Name of Project: Cell 8 Construction - J.E.D. Solid Waste Management Facility

Regarding: Omni Waste of Osceola County, LLC
J.E.D. Solid Waste Management Facility, St. Cloud, Florida
Cell 8 Construction; Response to "Review of Construction Certification Report"

**CONSTRUCTION QUALITY ASSURANCE
CERTIFICATION REPORT
CONSTRUCTION OF CELL 8**

D
3 SECTION (TYPICAL)
LINER SYSTEM TERMINATION AT INTERCELL BERM
SCALE: 1" = 2'

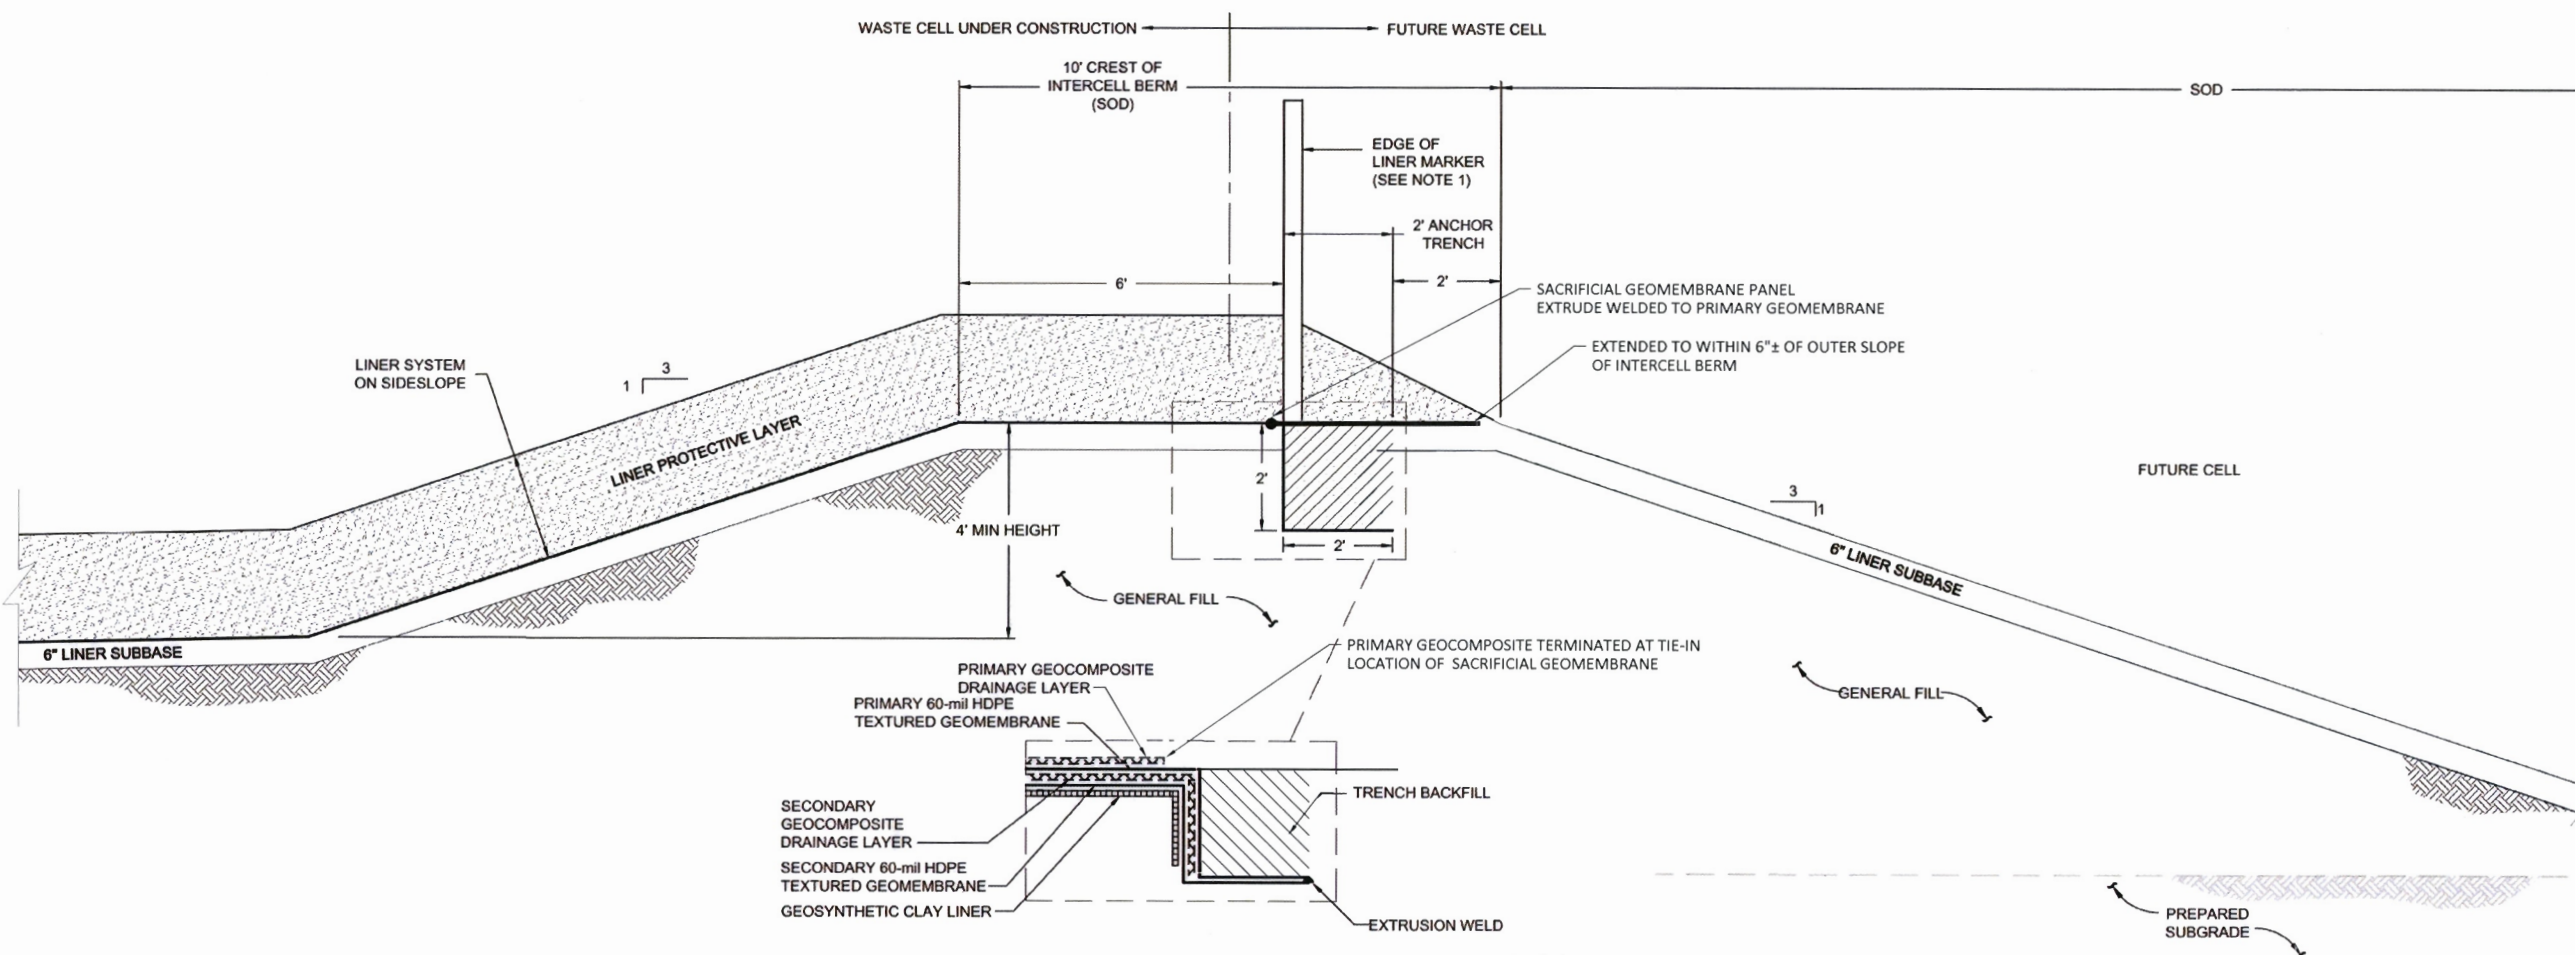
The intercell berm anchor trench design was revised as shown on the enclosed "Liner System

Termination at Intercell Berm" detail drawing.

- 5. Page 25 of the Report states “A sacrificial geomembrane panel was then extrude welded to the primary geomembrane liner at the crest point of the anchor trench and extended to the outer slope of the intercell berm (daylighted). The primary geocomposite was extended over the top of the sacrificial geomembrane and also daylighted at the outer slope of the intercell berm. This method of termination of the primary geocomposite will reduce migration of landfill gas into the intercell berm soils ...”**

- a. This is a significant deviation from the permitted design of the intercell anchor trench. Resubmit the DEP Certification of Construction Completion of a Solid Waste Management Facility form 62-701.900(2) and detail this change under ‘Deviations from Plans and Application Approved by DEP.’**

The form has been revised as requested with this change noted. The revised form is included in this response package.

On April 30, 2012, Omni received an e-mail from Ms. Kim Rush of the FDEP notifying Omni that the Air Resources Department would not authorize venting of the geocomposite at the intercell berm. This approach would apparently not meet conditions of the Facility's air construction and operating permits. Omni remobilized the Cell 8 earthwork contractor on May 3rd and began removing the vented section of geocomposite. The geocomposite was removed to the limits shown on the revised as-built detail "Liner System Termination at Intercell Berm" provided with this response package and Appendix A of the Report. Weaver Boos observed removal of the geocomposite, and replacement of the protective cover soils and sod. The work was completed on May 7th. A daily summary and pictures documenting the work are provided with this response package.

D
3 SECTION (TYPICAL)
LINER SYSTEM TERMINATION AT INTERCELL BERM
SCALE: 1" = 2'

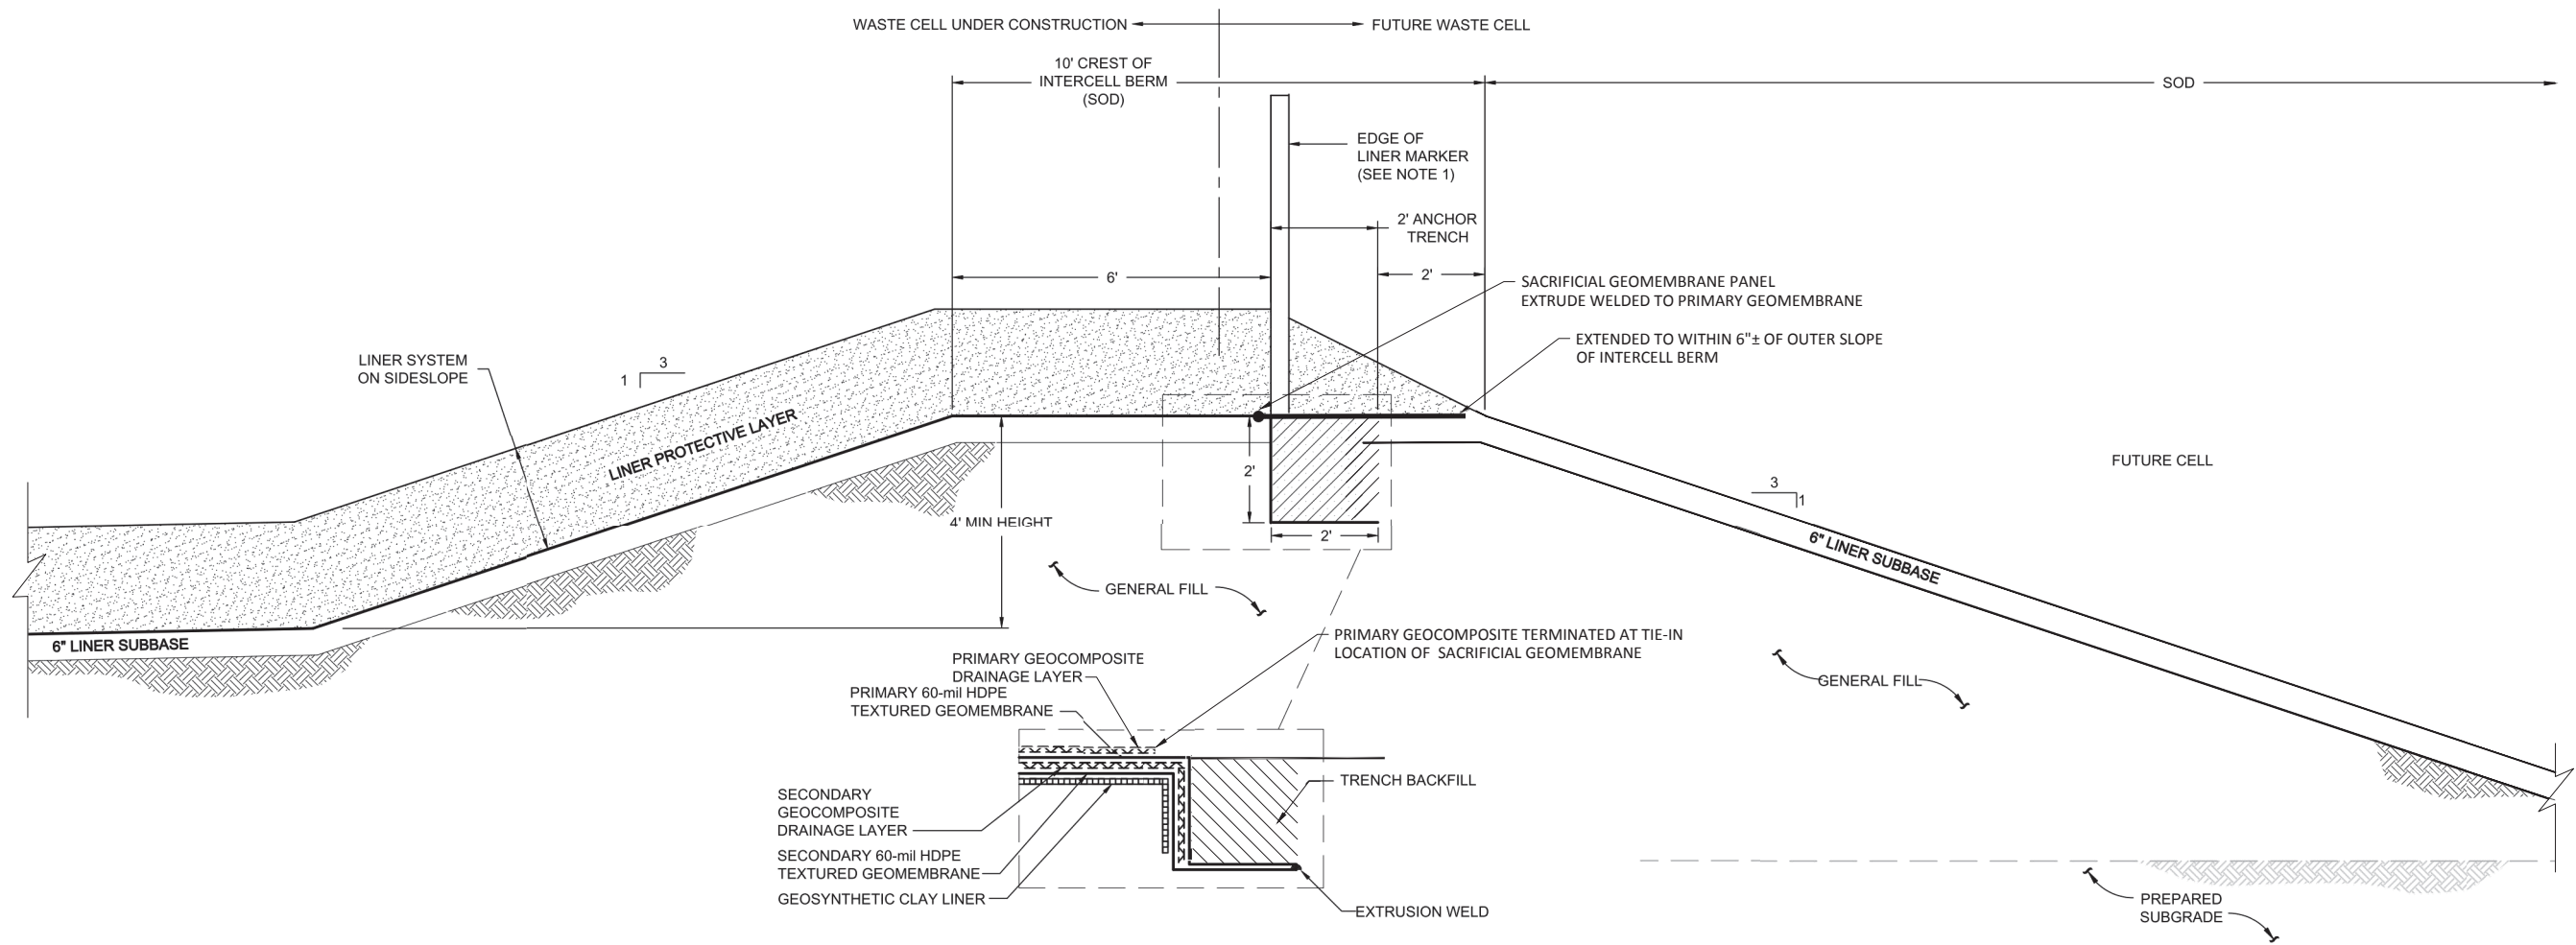
- 5. Page 25 of the Report states “A sacrificial geomembrane panel was then extrude welded to the primary geomembrane liner at the crest point of the anchor trench and extended to the outer slope of the intercell berm (daylighted). The primary geocomposite was extended over the top of the sacrificial geomembrane and also daylighted at the outer slope of the intercell berm. This method of termination of the primary geocomposite will reduce migration of landfill gas into the intercell berm soils ...”**

- a. This is a significant deviation from the permitted design of the intercell anchor trench. Resubmit the DEP Certification of Construction Completion of a Solid Waste Management Facility form 62-701.900(2) and detail this change under ‘Deviations from Plans and Application Approved by DEP.’**

The form has been revised as requested with this change noted. The revised form is included in this response package.

On April 30, 2012, Omni received an e-mail from Ms. Kim Rush of the FDEP notifying Omni that the Air Resources Department would not authorize venting of the geocomposite at the intercell berm. This approach would apparently not meet conditions of the Facility's air construction and operating permits. Omni remobilized the Cell 8 earthwork contractor on May 3rd and began removing the vented section of geocomposite. The geocomposite was removed to the limits shown on the revised as-built detail "Liner System Termination at Intercell Berm" provided with this response package and Appendix A of the Report. Weaver Boos observed removal of the geocomposite, and replacement of the protective cover soils and sod. The work was completed on May 7th. A daily summary and pictures documenting the work are provided with this response package.
